ERRATA

TO THE TSB12C01A 1394 LINK LAYER CONTROLLER DATA MANUAL

(TEXAS INSTRUMENTS LITERATURE NO. SLLS219A, FEBRUARY 1997)

Figure 4–Y. Receive Self-ID Format

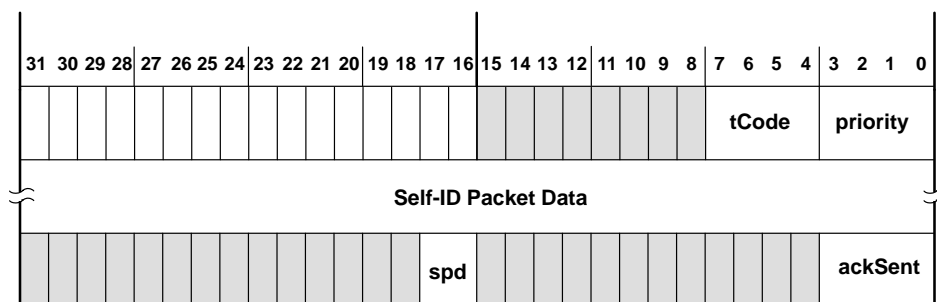
bb. Replace the *Receive Self-ID* paragraph, figure, and table where indicated in the specified documents, with the following paragraph, figure, and table.

The format of the receive Self-ID packet is shown in Figure 4–Y. The first quadlet is the packet header with the special tCode of Eh. The quadlets that follow are a concatenation of all the received Self-ID packets, followed by the final packet status quadlet.

Table 4–Z. Receive Self-ID Functions

FIELD NAME	DESCRIPTION
tCode	This field carries the special transaction code of 1110b.
priority	This field carries the priority level for this packet.
Self-ID packet data	This field contains a concatenation of all the Self-ID packets received.
spd	This field indicates the speed at which this packet was sent. All Self-ID packets are sent at the base rate of 100 Mbps. spd = 00 for 100 Mbps
ackSent	This field holds the acknowledge sent by the receiver for this packet.
